Kasli 2.0 and Kasli 2.0.1

Date: 2021-01-20
Doc. ID: PR-CTI-INS-1
Version: Ver1Rev1
Page: 1 of 3

Kasli 2.0 and Kasli 2.0.1 Modification Instruction

Figure 1

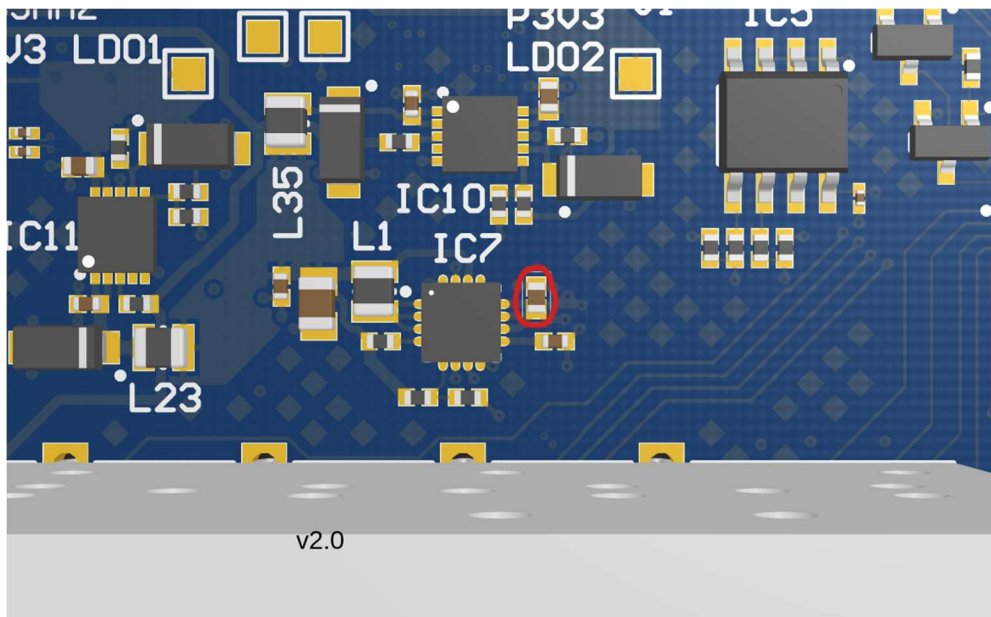
1. For Kasli 2.0 desolder the capacitor marked in Figure 1.

In place of the removed capacitor solder two pieces of CC0402_4.7UF_16V_20%_X5R on top of each other. The general work area is shown below on physical board:

Figure 2

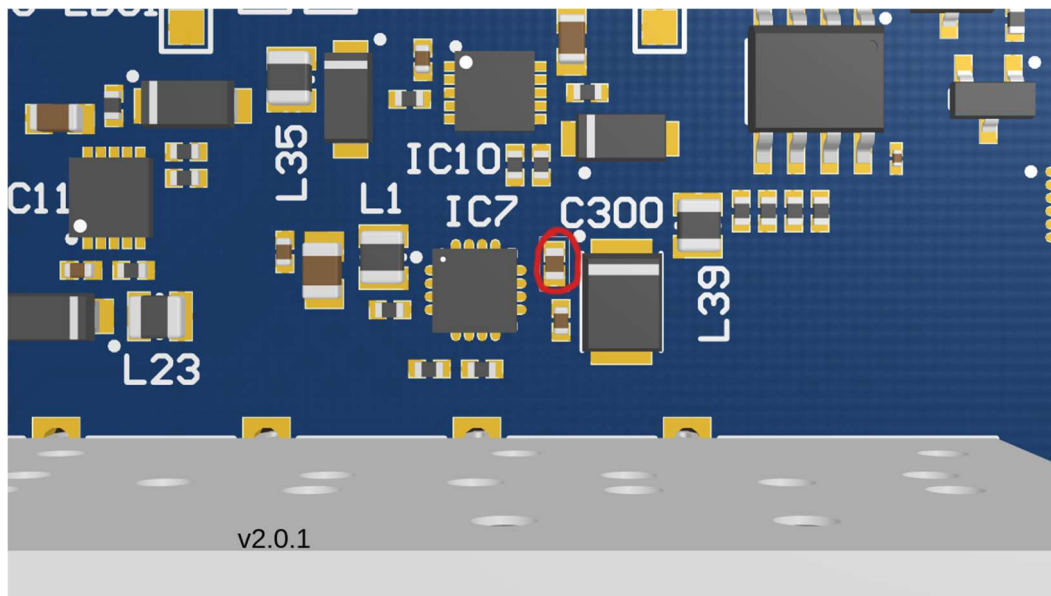
2. For Kasli 2.0.1 desolder the capacitor marked in Figure 2.

In place of the removed capacitor solder two pieces of CC0402_4.7UF_16V_20%_X5R on top of each other.

It is possible to use a single 16V X5R capacitor like 0603 (e.g. GRM188R61C106MA73D) or 0805 (e.g. GRM21BR61C106KE15K) instead of two pieces of CC0402_4.7UF_16V_20%_X5R soldered on top of each other. However, please note that this option will require more advanced soldering skills. In particular, in the case of Kasli v2.0.1 there is much less space for operating in between components and it might turn out to be impossible to fit in some models of 0603 or 0805 capacitors in this constrained space.
